**Written submission from the
Athabasca Chipewyan First Nation**

Cameco Corporation, Beaverlodge Project

Application for the Licence Revocation and
Transfer of Properties to Saskatchewan
Institutional Control Program

Application to release the final set of decommissioned Beaverlodge mine and mill site properties from CNSC licensing for acceptance into Saskatchewan's Institutional Control Program, resulting in the revocation of its waste facility operating licence

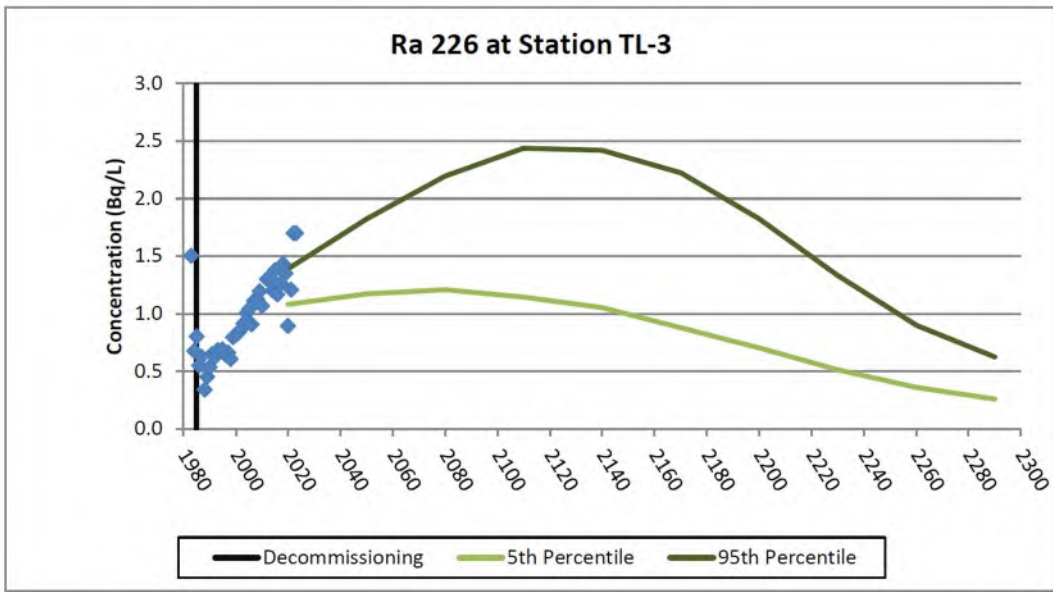
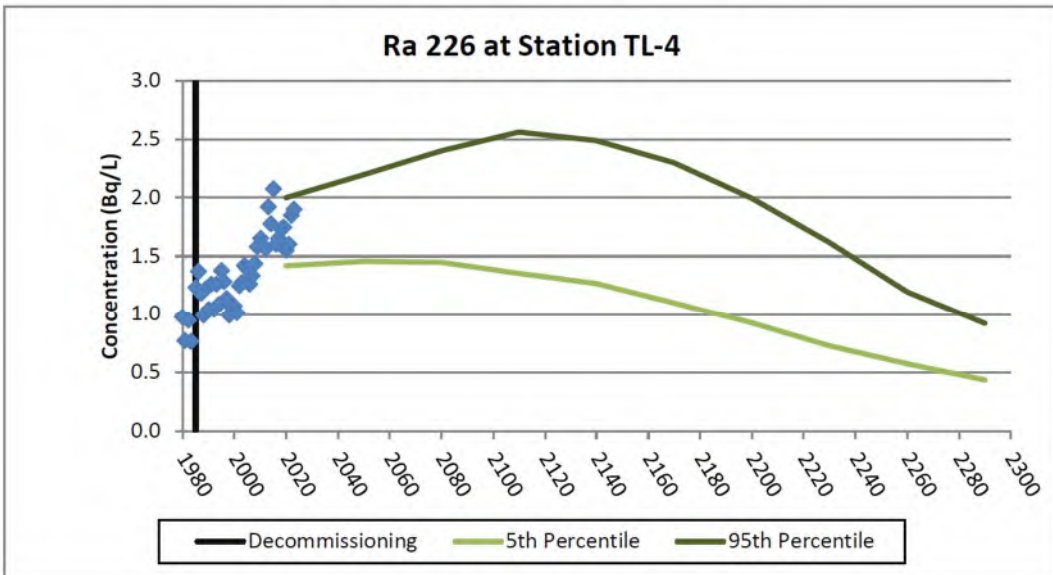
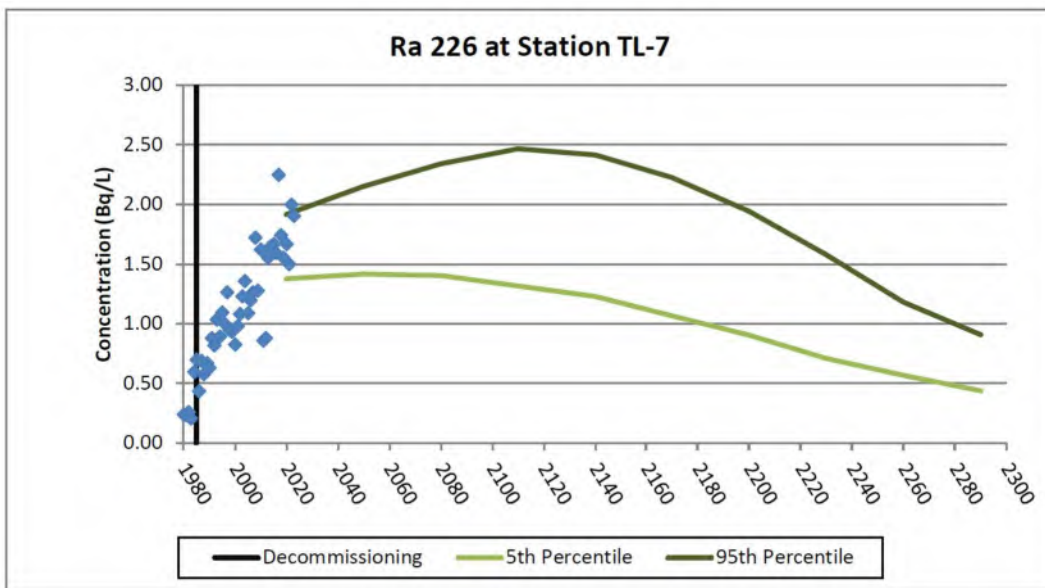
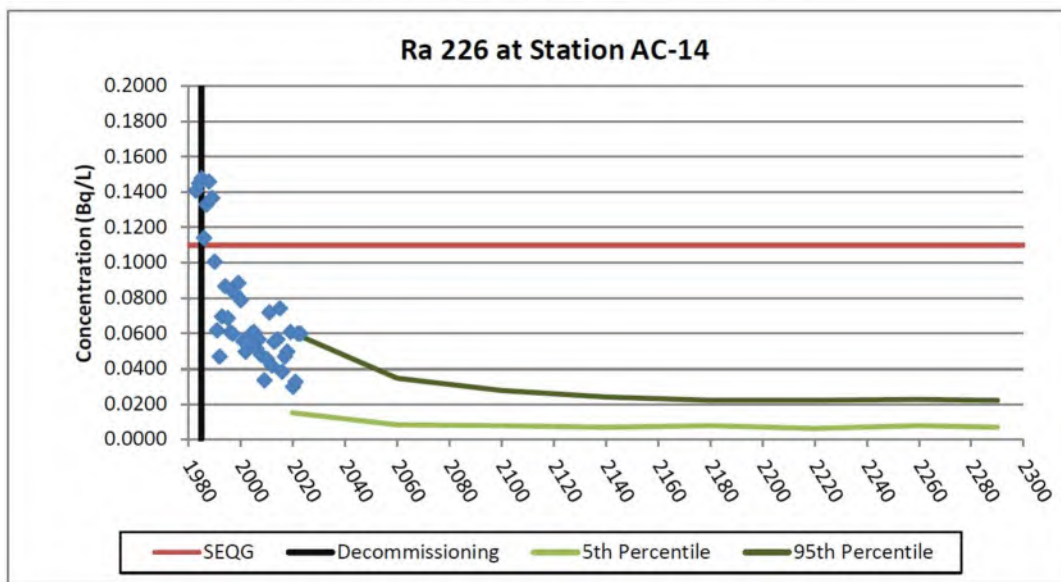
1)	Water quality performance objectives not met
Reference	Cameco Corporation 2024, Section 3.0, p. 19-61
Rationale / Review Comments:	
<p>Cameco's submission, as well as the CNSC submission (2024), affirm that the trend in water quality at all of the five designated monitoring locations fall within the modeled ranges that serve as the performance objective for the Beaverlodge properties. However, no trend lines or even averages for monitoring data are shown in the water quality figures provided (see figures below).</p> <p>Examination of some of the figures showing the concentration of radium-226 at the monitoring locations indicate that the observed concentrations exceed the 95th percentile of the modeled ranges, and may continue to do so, especially as they are currently increasing over time at three of these locations. The figures in question are reproduced below:</p>

It is difficult to know from these figures to what degree the measured concentrations are exceeding the performance objective, since no average or trend line is provided for the individual measured observations. Furthermore, the overlap between the measured and modeled concentrations is only about two or three years. A zoomed-in image for the overlapping years, as has been provided for uranium and selenium at some sites, would be very helpful. Notwithstanding these issues, from the figures provided, none of the monitoring records for the sites associated with the Fookes Reservoir, Marie Reservoir, Minewater Reservoir or Lower Ace Creek Reservoir properties appear to have met the radium-226 performance objective. Especially for the first three of these monitoring locations, the concentrations of radium-226 are still increasing, and could overshoot the performance objective range entirely. The assertion by Cameco and the acceptance by CNSC that the performance objective has been met is not supported. At a minimum, additional years of monitoring should be conducted to ensure that the performance objectives have been met and that no further mitigations and/or remediation are required at the Beaverlodge properties.

- a) Please provide zoomed-in figures for the radium-226 figures, focused on the years of overlap between the monitoring data points and modeling ranges.

- b) If trends for the monitoring data have been calculated, please add these lines to the figures for radium-226 discussed above. If no trend has been calculated, please explain why.

- c) Please add an annual average point for the monitoring data to the figures for radium-226 discussed above, if sufficient observations per year have been made.

Figure 3.3-3: U Performance Indicator at AC-6A

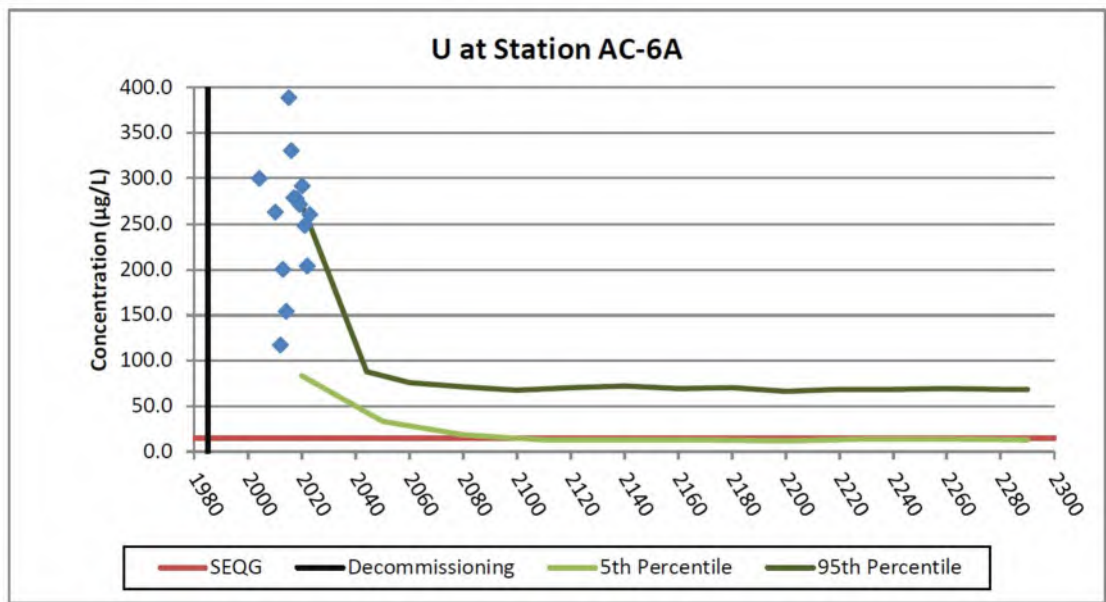
In addition, measured uranium concentrations are exceeding the modeled performance objectives at the Bolger property (figure reproduced below):

In the case of the high concentrations of uranium measured at the Bolger 1 property monitoring location, Cameco asserts and the CNSC accepts that "slightly elevated" concentrations in 2023 are the result of low flow conditions in the channel being monitored. However, the probabilistic modeling used to create the performance objective ranges would have incorporated the effects of low and high flows on water quality, including variability caused by climate change. Furthermore, the modeled range encompasses all but the most extreme conditions for that monitoring locations (5th through 95th percentiles). It is surprising then, that more than half of observed concentrations that overlap the modeled time period meet or exceed the modeled 95th percentile. The explanation for the observed uranium concentrations provided by Cameco and accepted by CNSC is therefore inadequate and actually calls into question the accuracy of the modeled performance objectives. Unfortunately, the

Figure 3: Recommended Fish/Water Monitoring Locations

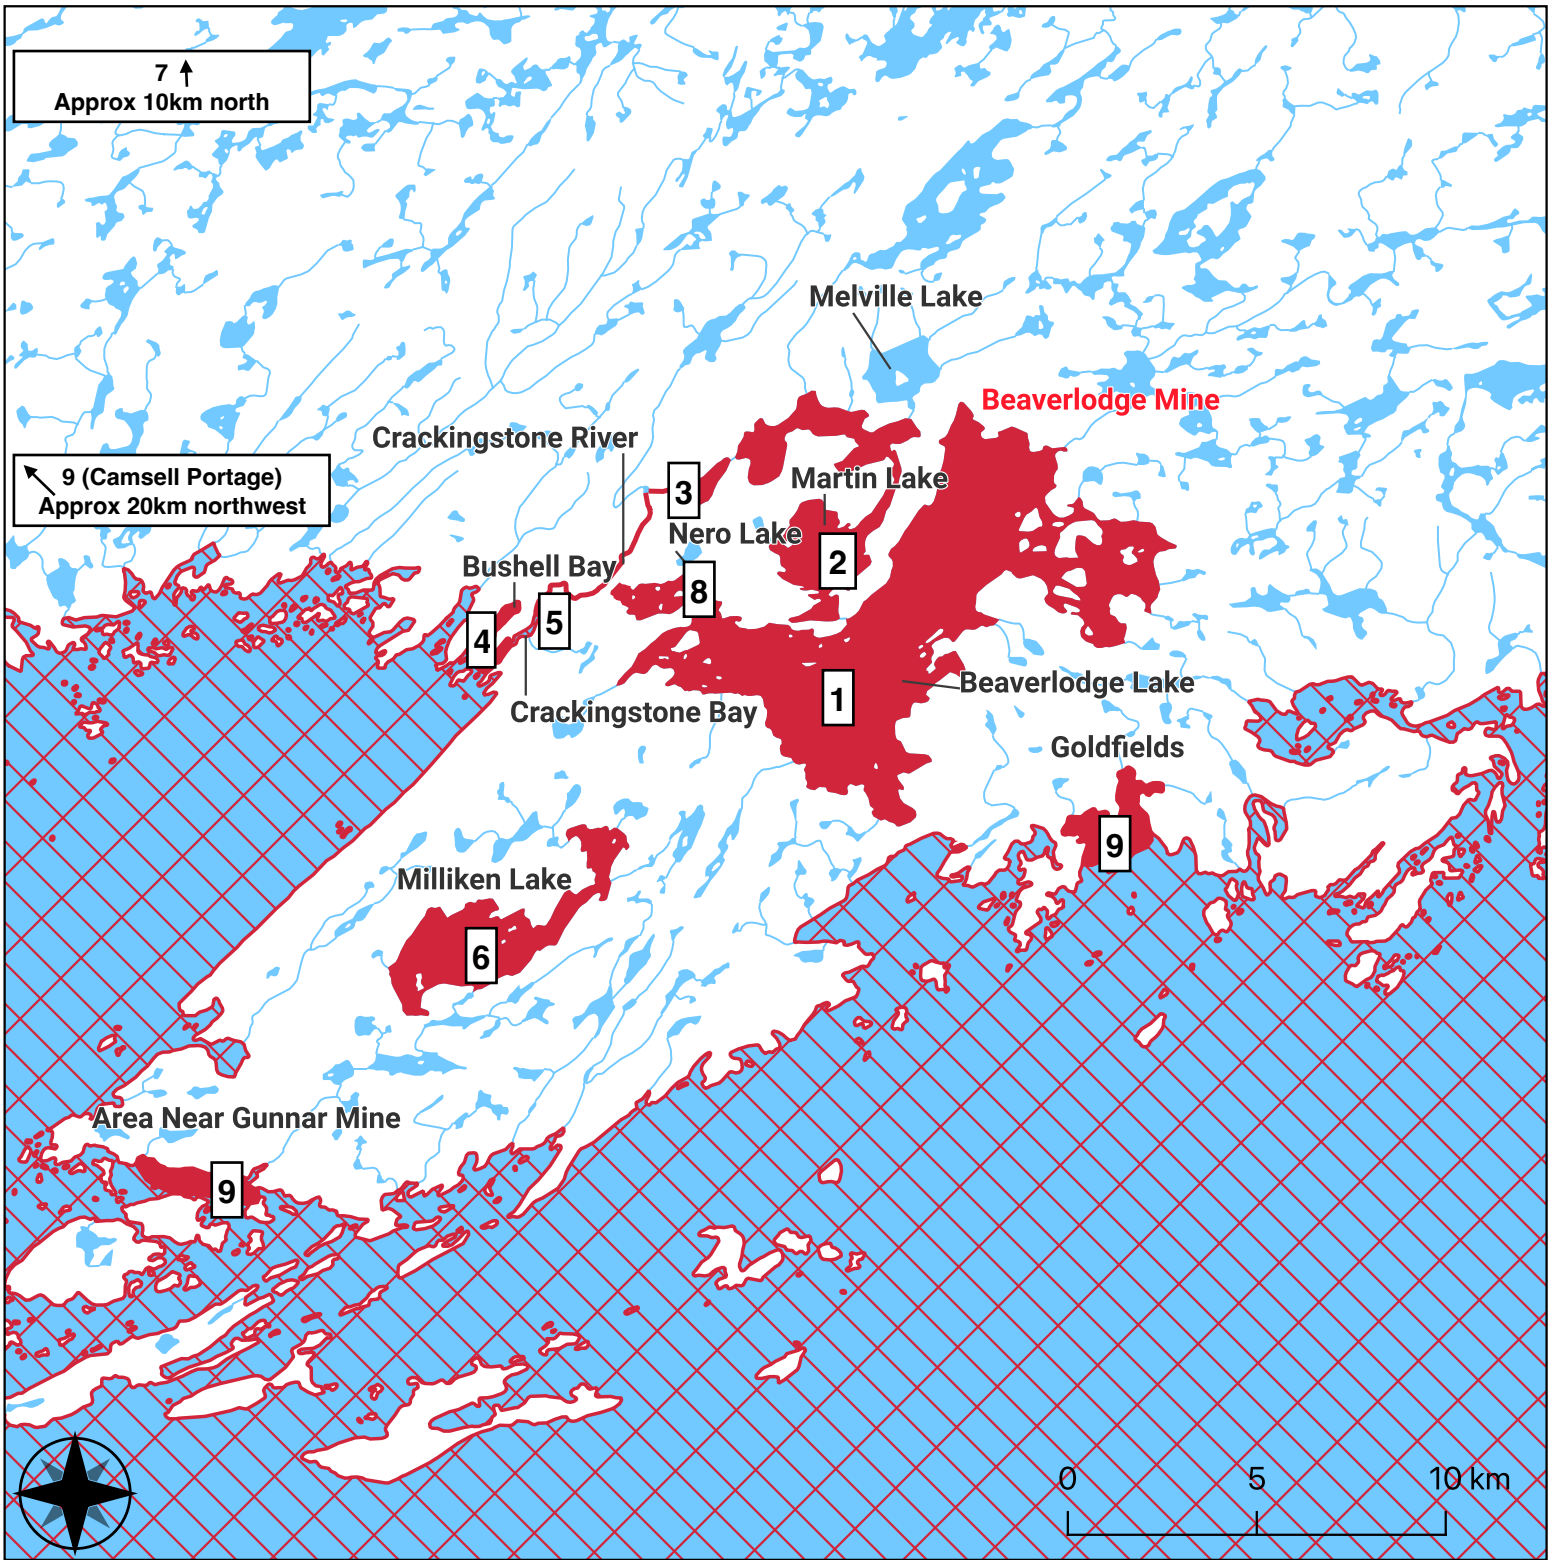
The areas identified by Respondents are shown in the map below in red (to maintain a reasonable map extent, some sites like Tazin Lake are not included in the map, nor is the entirety of Lake Athabasca). Given the size of Lake Athabasca and the challenges of identifying specific monitoring sites during a small number of interviews, Lake Athabasca is shown in a red crosshatch. As discussed above, Respondents identified several specific areas on Lake Athabasca where they anticipate there have been direct impacts from the Beaverlodge Mine and other mines and where fish/monitoring should take place. To their knowledge, monitoring has never been conducted at these sites or in Lake Athabasca more broadly, which is deeply concerning to them. Further research is required to identify additional sampling sites at greater distances in the lake.

2. That Cameco conduct monitoring in all locations that ACFN Respondents identified for this study or provide clear rationale as to why some areas will not be monitored;

Figure 2.1: Performance objectives and indicators

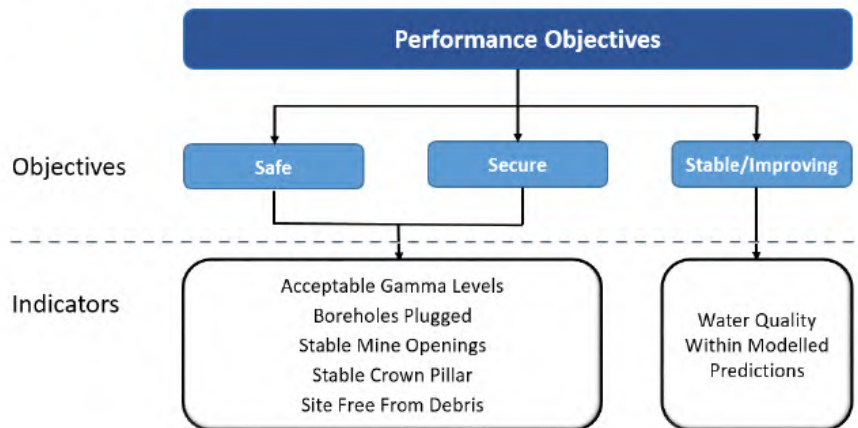
Rationale: The approved performance objectives, indicators and criteria do not include indicators for exposure pathways linked to sediment quality or biota (i.e., aquatic and benthic invertebrates, aquatic macrophytes (emergent and non-emergent), semi-aquatic wildlife) (Figure 2.1; CNSC 2024 reproduced below).

Reliance on management of surface water quality through comparison to modelling predictions is the sole consideration and is unlikely to protect and ensure aquatic ecosystems and habitat are safe for biological receptors.

This approach could limit the protection of human health for traditional land users such as ACFN who rely on plant and wildlife species for their way of life, including:

Recommendation/Request: CNSC update Table 4.1 with quantitative values indicating to status of each property as reported by Cameco (2024). Further, additional performance indicators and criteria for the safety of human health should be added based on responses to recommendations 1 and 2 and the table updated accordingly.

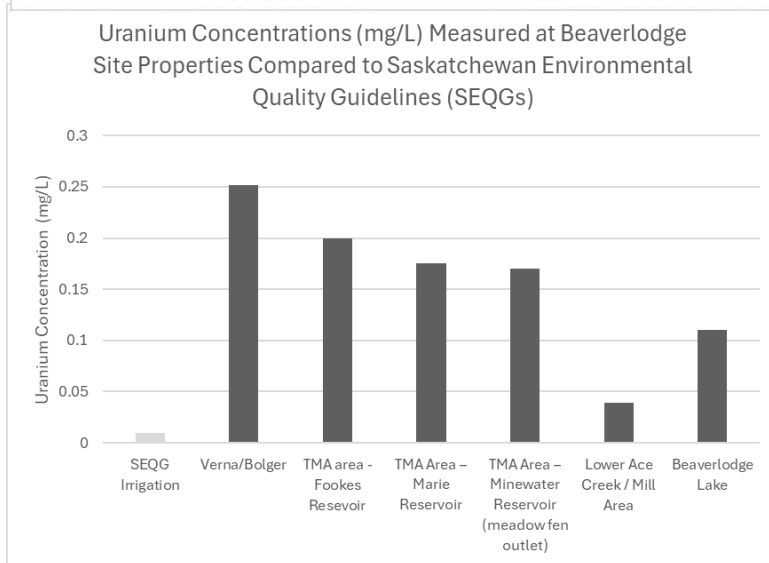
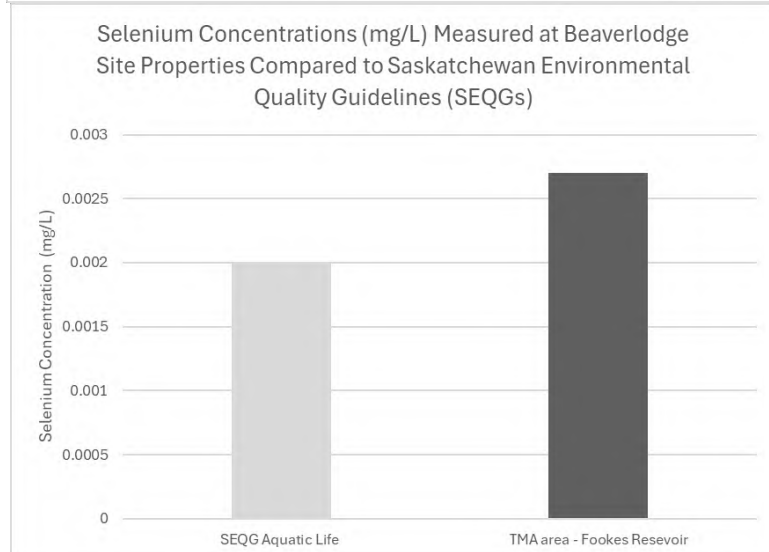
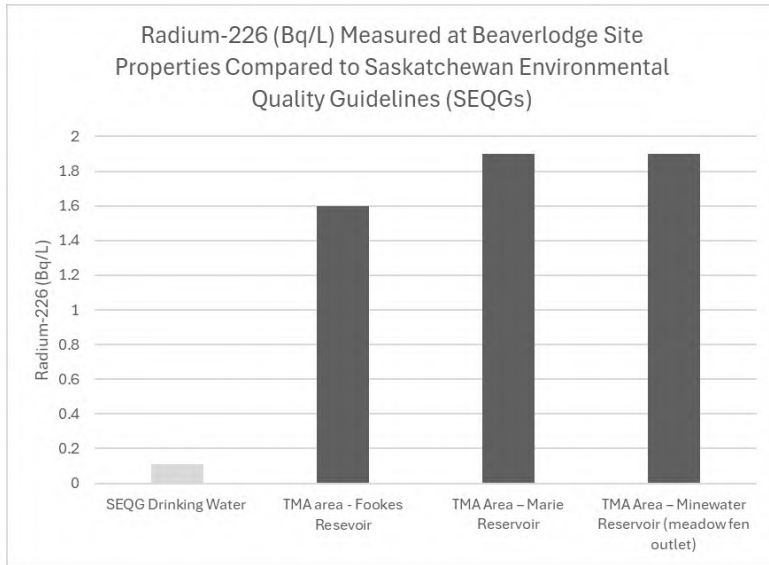
Rationale: The following graphs produced with data reported by CNSC summarized in the table below reported in the hearing submission by Cameco (2024) indicate the magnitude of SEQG exceedances for surface water quality at the various site properties and provide sufficient evidence that the approved performance objectives are not managing or mitigating health risks (unless consumption advisories and use restrictions are followed). The most notable exceedances are related to Radium 226 and Uranium

Recommendation/Request: CNSC require Cameco corporation to modify the performance objectives to an effects-based approach which requires Cameco to monitor and manage the 27 site properties based on observed environmental conditions to minimize and prevent adverse environmental and health effects and risks.
